Amendments to the Drawings:

REMARKS

ANNOTATED SHEET

Fig. 7

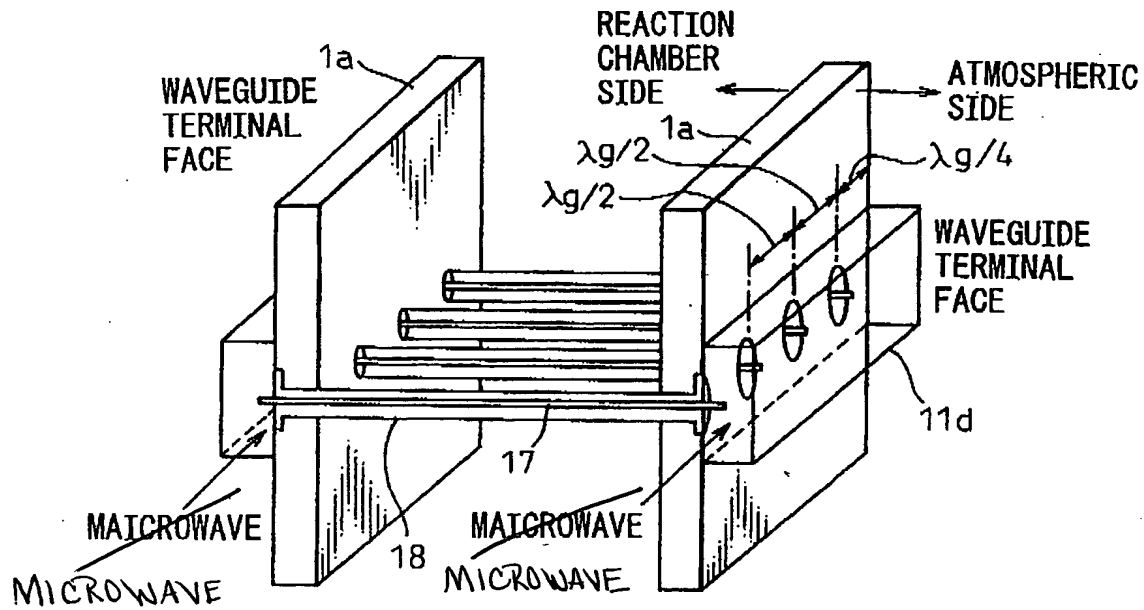
The attached sheets of drawings includes changes to Figs. 7, 19, 20, 21, 22, and 23. As suggested by the Examiner, in Figures 7, 19, 20, 22 and 23, "MAICROWAVE" has been changed to "MICROWAVE". Figure 21 has also been amended to change "MIROWAVE" to "MICROWAVE".

Replacement drawings are provided herewith as explained on the earlier page entitled “Amendments to the Drawings.” In response to the objections to the drawings, Applicants have amended Figures 7, 19, 20, 22, and 23 by changing “MAICROWAVE” to “MICROWAVE” and Figure 21 has been amended to change “MIROWAVE” to “MICROWAVE” as suggested by the Examiner, thereby rendering these objections moot. Reconsideration and withdrawal of these objections are therefore respectfully requested.
